CABINET MEMBER FOR ENVIRONMENT– 17 MARCH 2016

PROPOSED PUFFIN CROSSING A417 STANFORD IN THE VALE

Report by Deputy Director for Environment & Economy (Commercial)

**CONSULTATION PLAN
 ADVERTISED LOCATION**

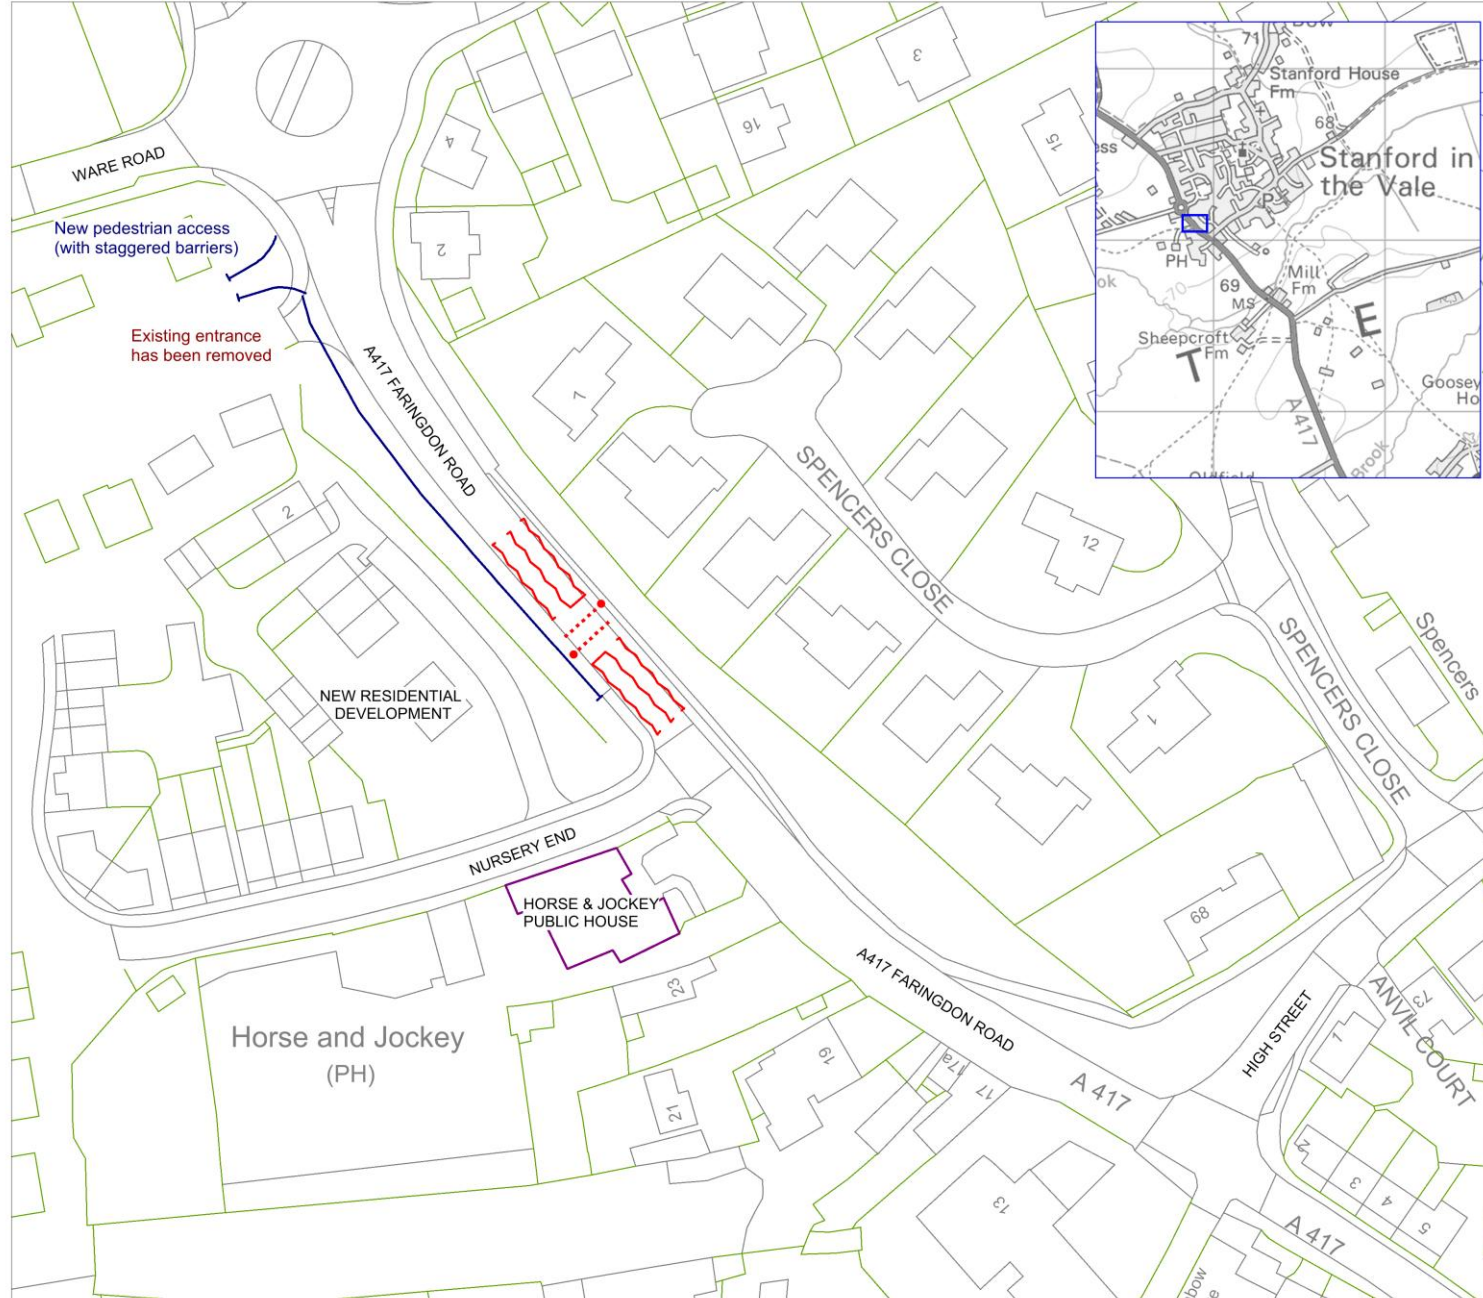
Objections / Comments	Officers response
Stanford in the Vale Parish Council	<p>Style of puffin crossing to have minimal street furniture. The puffin crossing should have no audio warning.</p> <p>Minimal & directional street lighting to be provided.</p> <p>VWHDC has confirmed a strategic housing site (200 dwellings) north of the current development. Will impact on probable usage of the crossing.</p> <p>Advertised location of puffin crossing is generally more acceptable than previous.</p>	<p>The signal equipment, including the numbers of poles & heads, will be provided in accordance with Department for Transport standards & specifications. Minimising the amount of equipment in line with the above parameters, providing hoods to the signal heads and turning the audible bleeper off overnight will all be investigated.</p> <p>The proposed street lighting does not form part of this consultation. It is to be provided irrespective of the puffin crossing provision.</p> <p>Decisions on where pedestrians are going to cross the A417 from such a development to access the village amenities will be made at the time of a full planning application.</p> <p>Noted</p>

Thames Valley Police	Have no objection to the proposal.	Noted
AGSR (A Group of Stanford Residents)	The crossing is not far enough north. It should be located closer to the Ware Road/Farm Piece roundabout. Consequently it is not on the pedestrian	Surveys carried out on 8 January 2016 indicated that the majority of pedestrians crossed Faringdon Road at the Nursery End junction/outside the Horse & Jockey Public House, not at the existing refuge just south of the

<p>desire line.</p> <p>No assessment has been made of the actual need for a puffin crossing (footfall patterns & volumes).</p> <p>Other, busier, roads in Oxfordshire such as the A420 at Watchfield/Shrivenham and the A338 at East Hanney only have pedestrian refuges. Why do we need a puffin (signalled) crossing on Faringdon Road, Stanford in the Vale?</p> <p>The two long established & useful dropped kerbs close to the Pub and Garage should be maintained for the future convenience of village residents.</p>	<p>roundabout.</p> <p>See above response. The recommended location for the puffin crossing is 12m SE of its advertised location. This will place the crossing as close as possible to the desire line of the majority of the expected users.</p> <p>The County Council sought to obtain the best/safest type of pedestrian crossing for the residents of Stanford in the Vale. Residents frequently request improved pedestrian crossing facilities on other busier roads such as the A338 & A420.</p> <p>The existing dropped kerbs do not form part of this consultation.</p>

<p>Resident, Spencers Close</p>	<p>No technical study as to best place.</p> <p>Advertised puffin crossing position is a compromise which is no use to anyone.</p> <p>The need for a puffin crossing & associated street lighting is unnecessary urbanisation. A refuge should suffice</p>	<p>Surveys carried out on 8 January 2016 indicated that the majority of pedestrians crossed Faringdon Road at the Nursery End junction/outside the Horse & Jockey Public House. Therefore the recommended location for the puffin crossing is 12m SE of its advertised location.</p> <p>The recommended location places the crossing as close as possible to the desire line of the majority of the expected users.</p> <p>The County Council sought to obtain the best/safest type of pedestrian crossing for the residents of Stanford in the Vale. The proposed street lighting does not form part of this</p>

<p>when compared to other new 'similar' developments in Oxfordshire. Already a refuge at the roundabout end; put another refuge in at the Pub/Garage end.</p> <p>Advertised puffin crossing position is not on the pedestrian desire line for residents of the new development. In particular, teenagers crossing the road to catch a school bus will not use it. Also, pedestrians coming out of the High Street to visit the pub will not use it.</p> <p>Advertised puffin crossing position is outside of this resident's property. He does not want it here, particularly as the chosen location is not based on County Council research and investigation.</p> <p>If proposal goes ahead, hopes there will be an opportunity to consult on the detail of the traffic lights themselves, the warning bleeper and any additional screening that can be put in place to minimise disruption to his property.</p>	<p>consultation. It is to be provided irrespective of the puffin crossing provision. Faringdon Road is too narrow at the Pub /Garage end to accommodate a refuge.</p> <p>Agreed. The recommended location for the puffin crossing is 12m SE of its advertised location. This will place the crossing as close as possible to the desire line of the majority of the expected users.</p> <p>The recommended location for the puffin crossing is no longer outside of this resident's property. However, it is now outside the rear of his neighbour's property. Research & investigation has been carried out by County Officers in order to select this location.</p> <p>Issues around the detail of the traffic lights have been raised by some as part of this consultation. The signal equipment, including the numbers of poles & heads, will be provided in accordance with Department for Transport standards & specifications. Minimising the amount of equipment in line with the above parameters, providing hoods to the signal heads and turning the audible bleeper off overnight will all be investigated. The signal heads on the NE side of Faringdon Road are approximately 7m from the back fence of the nearest Spencer Close property. Additional screening is not considered necessary.</p>

<p>Will be looking to make a claim under the Land Compensation Act.</p>	<p>Noted.</p>
<p>Resident, Spencers Close (at same address as above)</p>	<p>No evidence or narrative to show that full consideration has been given to the best/ chosen position of the puffin crossing.</p> <p>No evidence or narrative to show that due consideration has been given to the types of crossing available and that a puffin crossing is best for this location. It would totally urbanise this stretch of Faringdon Road.</p> <p>The position of the puffin crossing would not benefit the whole community.</p> <p>No evidence or narrative to show that the chosen crossing position is safe in terms of pedestrian/driver inter-visibility.</p> <p>Advertised puffin crossing position is adjacent to this resident's property. The crossing will be a nuisance in respect of noise (audible signal, users, & traffic flow); light pollution (street lighting & traffic lights); and particulate pollution/</p>	<p>Surveys carried out on 8 January 2016 indicated that the majority of pedestrians crossed Faringdon Road at the Nursery End junction/outside the Horse & Jockey Public House. Therefore the recommended location for the puffin crossing is 12m SE of its advertised location.</p> <p>The County Council sought to obtain the best/safest type of pedestrian crossing for the residents of Stanford in the Vale. The Planning Inspector's view was that this stretch of Faringdon Road is already semi-urban & that the addition of a puffin crossing would not constitute a significant change.</p> <p>The recommended location places the crossing as close as possible to the desire line of the majority of the expected users.</p> <p>Both the advertised & recommended locations for the puffin crossing accord with the visibility requirements of Local Transport Note 2/95. Siting the crossing at its recommended location increases the inter-visibility.</p> <p>The recommended location for the puffin crossing is no longer outside of this resident's property. However, it is now outside the rear of her neighbour's property. Turning the audible signal off overnight and providing hoods to the traffic lights will both be investigated. The proposed street lighting does not form part of this consultation. It is to be provided</p>

<p>Resident, Faringdon Road</p>	<p>No public consultation.</p> <p>No evidence based decision on location.</p> <p>Crossing should be located at the pedestrian access point at the NW end of the development, adjacent to the Ware Road/Farm Piece roundabout. This is the natural point for a number of reasons.</p> <p>Other roads such as the A338 & A420</p>	<p>This document reports the results of the public consultation.</p> <p>Surveys carried out on 8 January 2016 indicated that the majority of pedestrians crossed Faringdon Road at the Nursery End junction/outside the Horse & Jockey Public House.</p> <p>See above response.</p> <p>The County Council sought to obtain the best/safest type of</p>

14. In light of this, officers have undertaken surveys in order to confirm where the majority of pedestrians cross A417. The surveys were carried out on Friday 8 January 2016 between 07:30-09:30 and 14:30-16:30. At the time of the survey the pedestrian access at the north-western end of the development had been completed with 50 of the 73 dwellings occupied. The results from both of the surveys were the same with 20 crossing A417 in the vicinity of the Public House and only 4 crossing at, or just south of, the Ware Road/Farm Piece roundabout.

15. The pedestrian surveys have shown that if the puffin crossing is to be located between Nursery End and the Ware Road/Farm Piece roundabout then it should be moved as near as it can safely go towards the Nursery End junction. This places the crossing near to the desire line of the majority of the expected users. The further north the crossing goes, the less likely it is that these pedestrians will deviate from their desire line in order to use it. Consequently it is recommended that the puffin crossing is implemented as shown on the plan at Annex 3 (which is approximately 12m SE of the position).

**CONSULTATION PLAN
RECOMMENDED LOCATION**

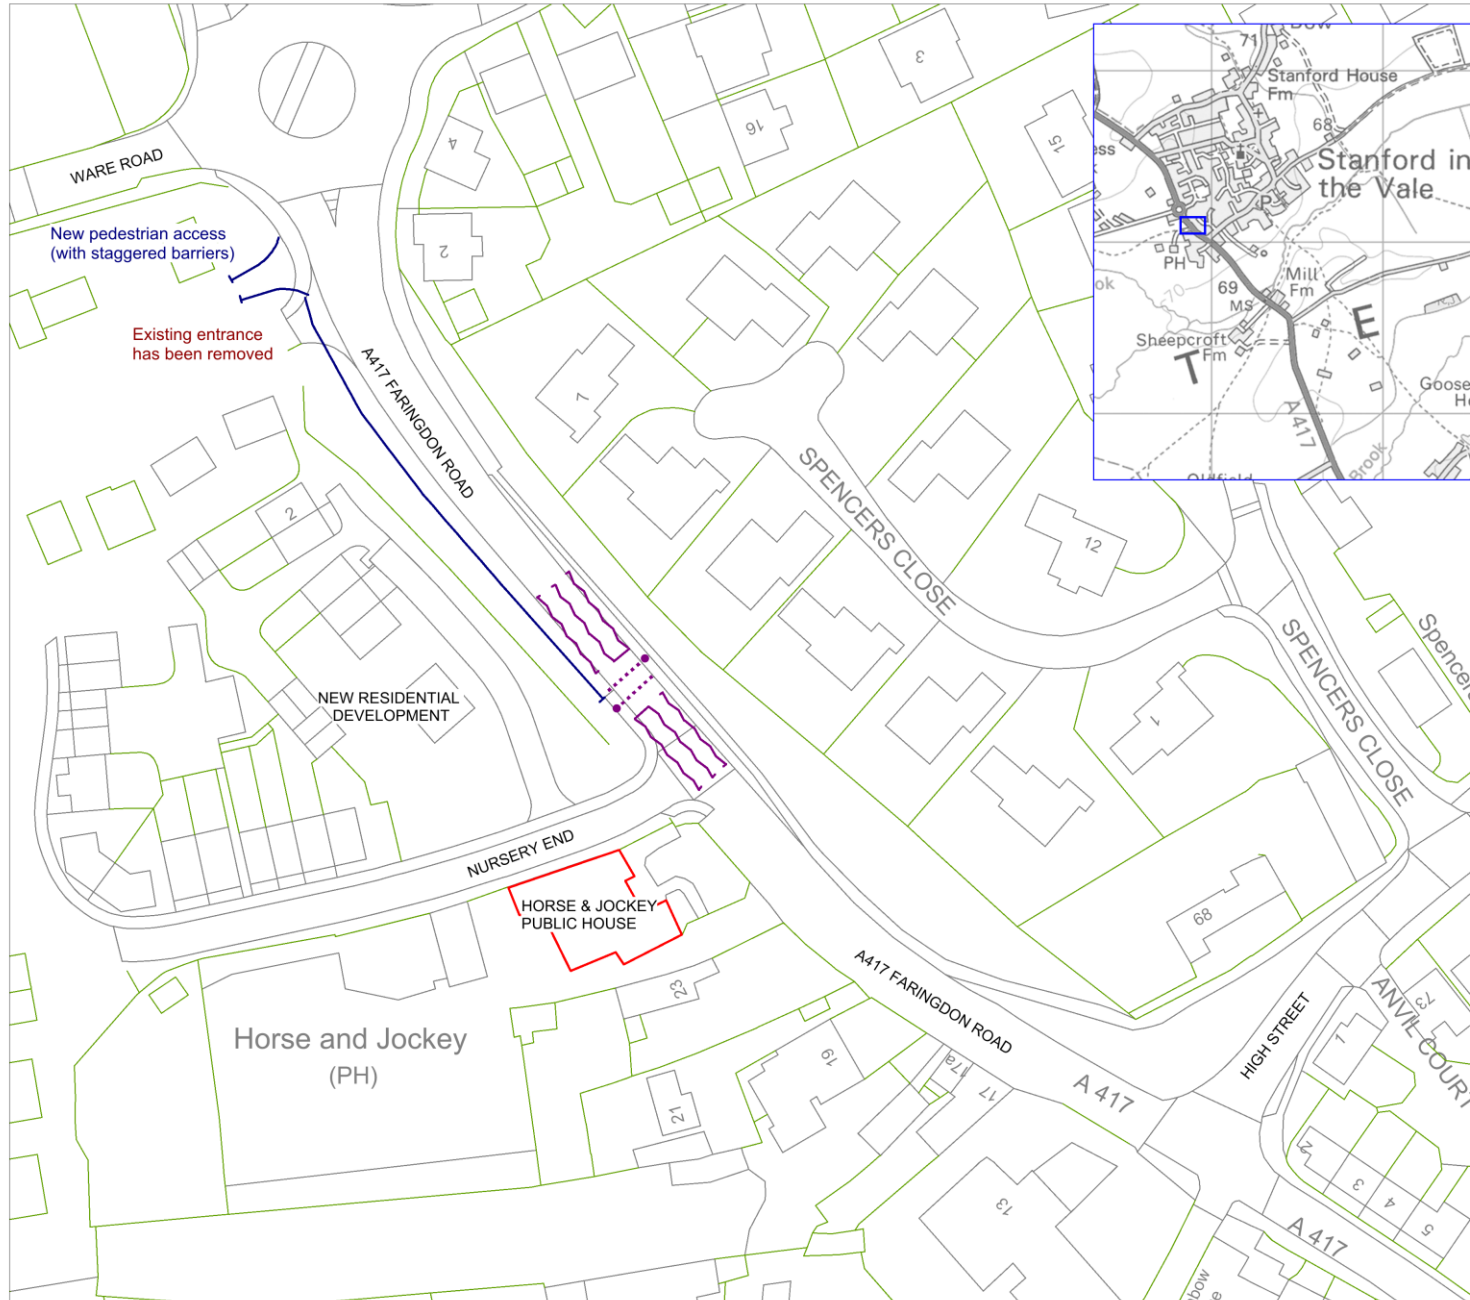
12. **The Cabinet Member for Environment is RECOMMENDED to approve the implementation of the proposed puffin crossing approximately 12m south east of the advertised position as described in this report.**

- Notes.
- * Distance from left turn drivers position at Nursery End 'give way' line to A417 Puffin STOP line - 10m.
 - * Width of crossing - 3m.
 - * Distance between Puffin STOP line and studs - 3m.
 - * Distance from Nursery End centre line to Puffin centre line - 17.3m.
